WASTE PICKLE LIQUOR WELL #2

DETAILED SCHEMATIC OF WPL-2

DATE: 12/29/2009	JOB NO.: 70A6378
ATTENTION: Lisa Perenchio	
RE: Report of Well Closure and Post-Closure Operations - U.S. Steel Corp. - Waste Pickle Liquor Well No. 2

FIGURE 1-2
MIDWEST OPERATIONS
NATIONAL STEEL CORPORATION
PORTAGE, INDIANA

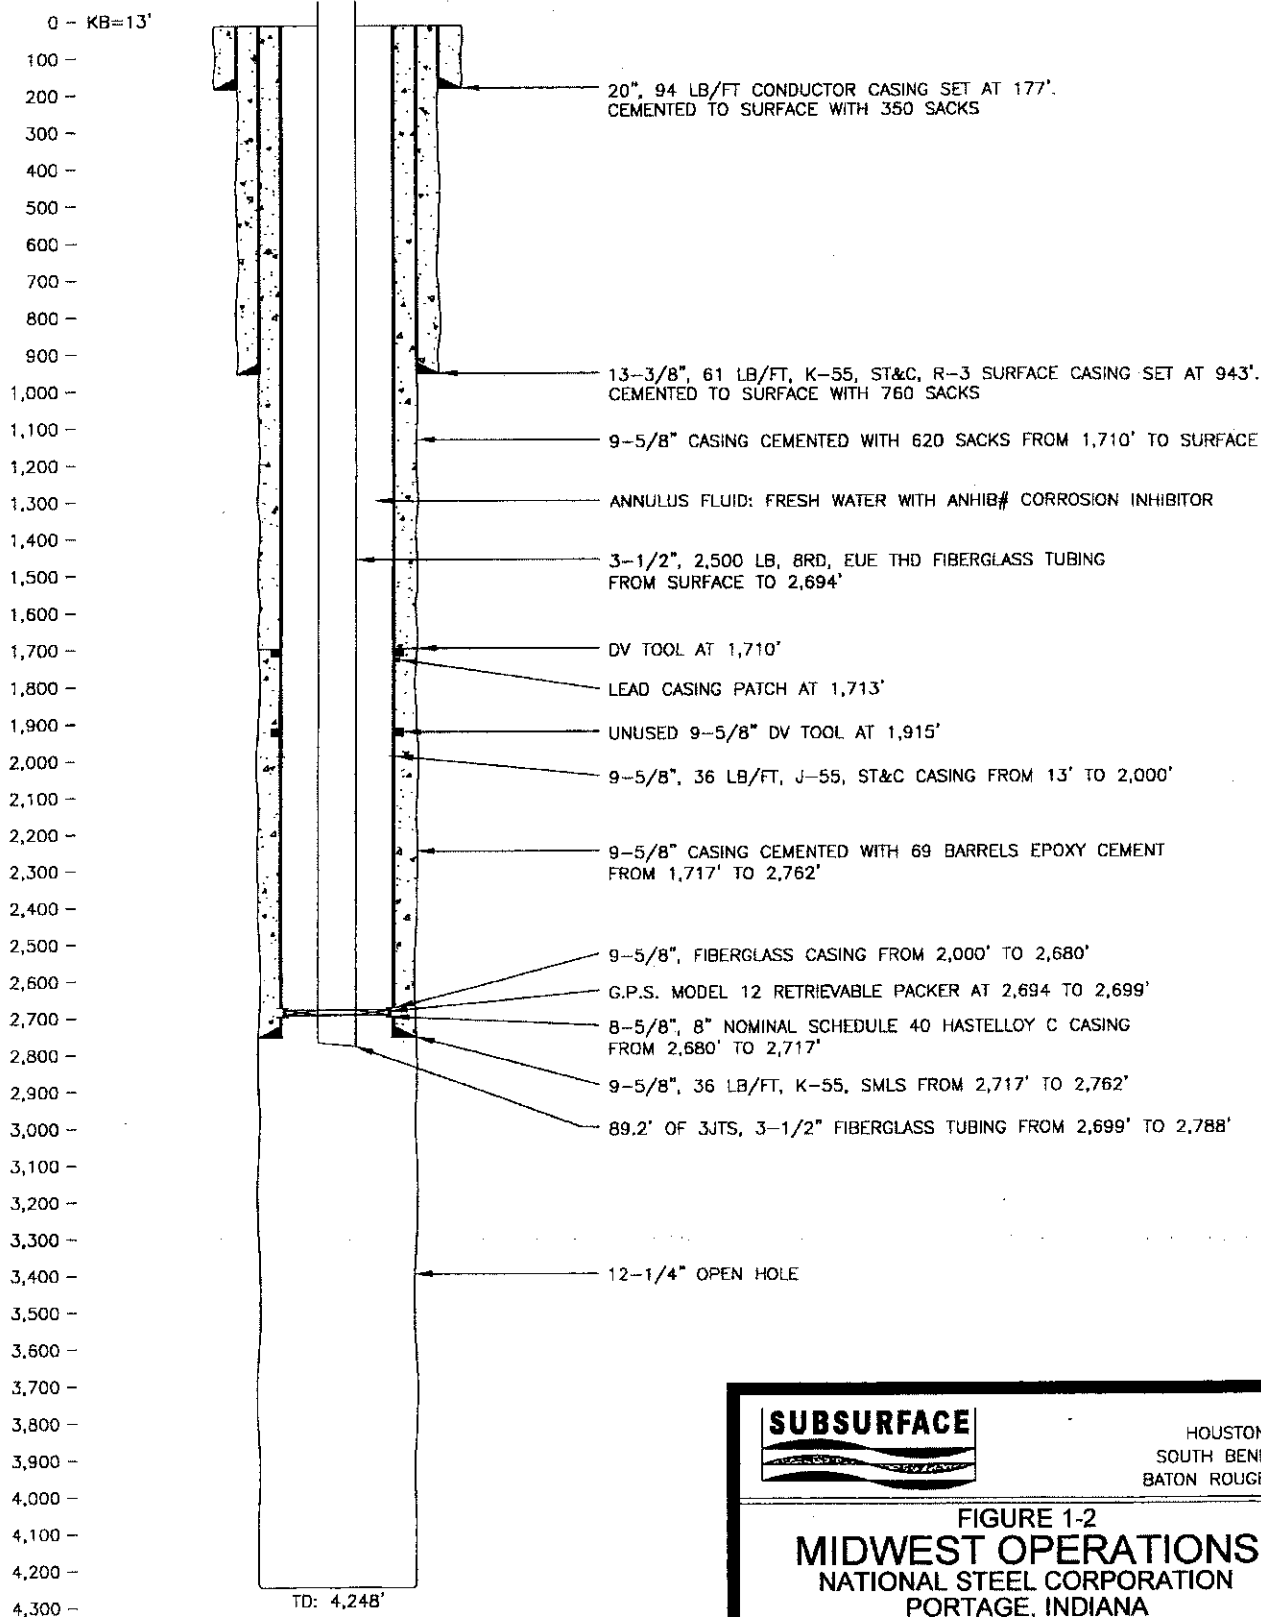
- 1) The ID of the 9-5/8 fiberglass 7.840" Min. Drift 7.750"
- 2) The ID of the Hastelloy 7.98"
- 3) The rationale for putting the epoxy plug at the indicated depth is that at this depth the condition will exist where there will be a hastelloy casing incased in a epoxy seal. If the epoxy plug was put in the open hole there exists a possibility that left over acid could weep between the epoxy plug and the formation.
